UNITED STATES
ATOMIC ENERGY COMMISSION
WASHINGTON, D.C. 20545

TWO PUMP OPERATION OF TWO LOOP-4 PUMP REACTORS

Calvert Cliffs Plant

FIG. 2

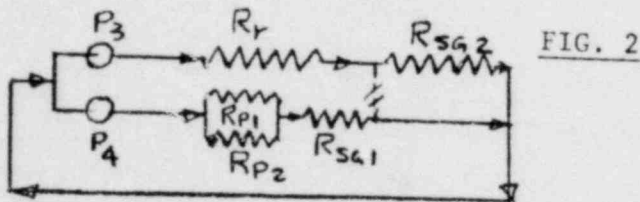
In an effort to determine the cause of the difference in calculations, FIG. 1 was revised to FIG. 2 configuration. This represents one possible error in the manufacturers codes.

Solving this configuration we find the reactor flow at 47.8 compared to the manufacturers value of 47%. This configuration is physically impossible to achieve. Since manufacturers find flows almost equal for either two pump operation, their Tech Specs do not differentiate between the two.

Since our calculations show the one condition flow much greater than the other, it is suggested that the Project Leaders be aware of this apparent anomaly. They may want to clarify their particular situation to their satisfaction. Careful flow testing in the field will provide conclusive answers required for reactor safety.
